**PR/0643/22**

## Record of Executive Business and Chief Executive's Order

**Reg. Reference:** SD21A/0333

Demolition of existing garage to side; construction of new 2 storey dwelling to the side of the existing dwelling; new storm water percolation area to rear; new car parking provision for 2 vehicles accessible from Heatherview Avenue; associated site works.

**Top:** Extract from SDCC maps showing areas taken in charge in yellow. Note No. 50 is the subject site. **Bottom:** Screenshot of Property Registration Authority Maps, with land parcel of No. 50 highlighted. Neither is guaranteed to provide an accurate representation of land ownership.

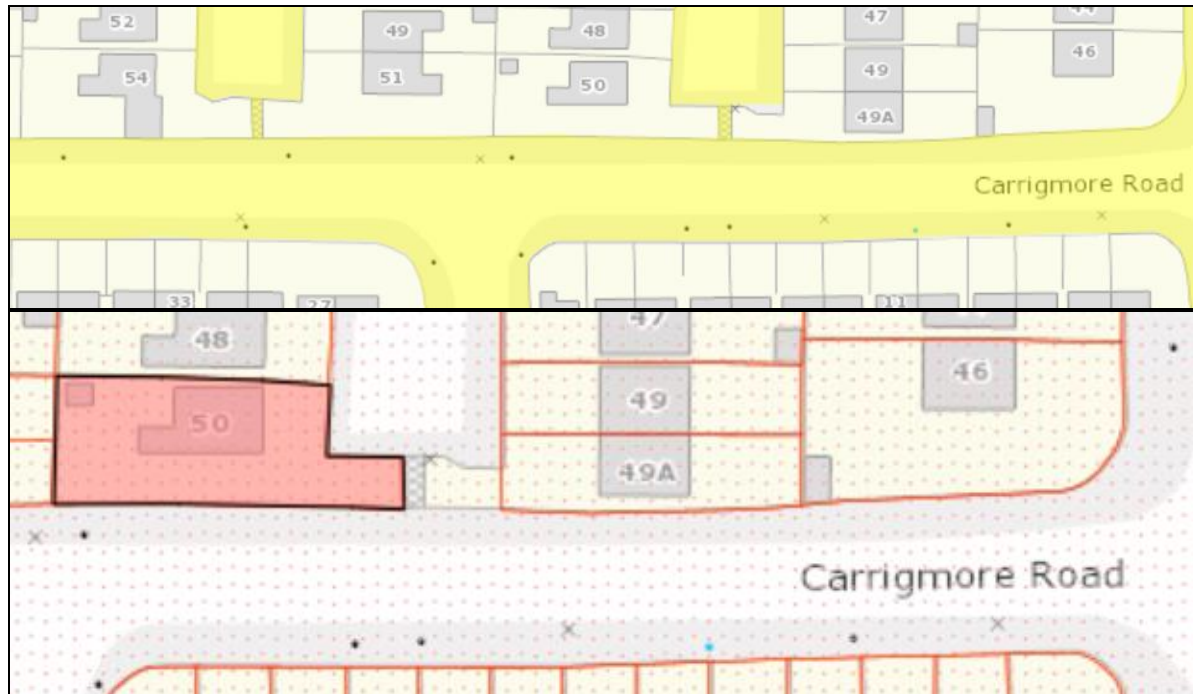
Measurements taken from aerial photograph appear to show the applicant's boundary being approx. 13.2m from the front building line of the existing garage; however, the site layout plan and floor plans taken together show a measurement of 14.2 metres between this same point and the far edge of the vehicular access (1.7m front projection at ground level and 12.789m distance marked on layout plan between front of house and edge of site). There is therefore a question as to whether the proposed development would include the enclosure of SDCC owned lands.

The applicant should be invited to comment on the ownership boundary by way of **additional information**.

(a) The applicant has confirmed that they do not own the strip directly east of the application site and that their own development will not encroach upon it.

(a) Response to (a) is adequate.
